Complaint - Softclose Non-Functional: Replacing Bowden Cable for Inner Door Lock Release (26/23)

Model Line: **Panamera (971)**

Concerns: **Bowden cable for inner door lock release**

Adhesive pad

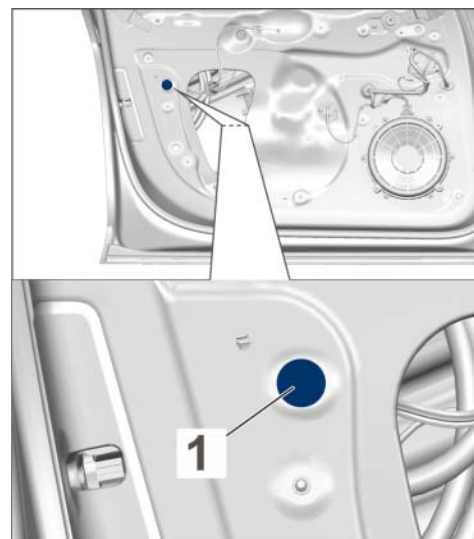
When installing instead of the originally installed adhesive pad ⇒ *Adhesive pad -1-*, use a piece of adhesive tape V04015800B measuring 40 x 40 mm/ 1.57 x 1.57 in to close the cut-out.
